AES Technical Bulletin

Auger Delron Bushing between Auger and Auger Plate

Product Models Covered: ALL Magnum Baby Countryside & Winchester models

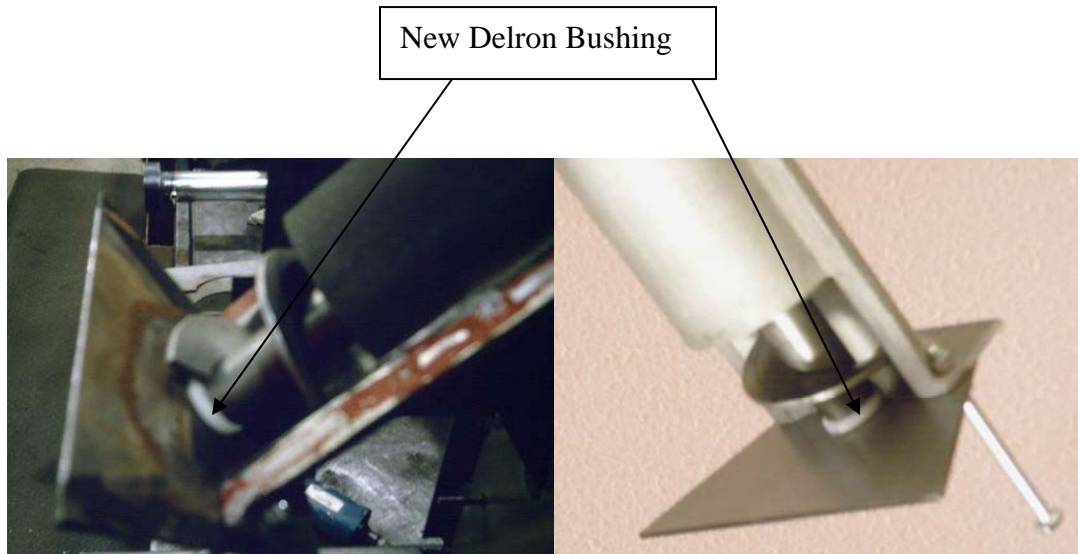
What to look for: There has been a new delron bushing with a longer flange that extends toward the auger motor installed between the auger and auger plate. This is to help alleviate the play between the auger and auger plate so that the bushing does not fall out of the plate.

You will be able to tell if you have an upgraded delron bushing by looking at the serial number, located on the back of the unit. If the serial number is greater than # 13870 (for the Magnum Baby Countrysides) you have the upgraded delron bushing in the unit. There is no need for current owners to upgrade to the new delron bushing, however if they want to upgrade they can purchase it from their local dealer. The part number is P1178
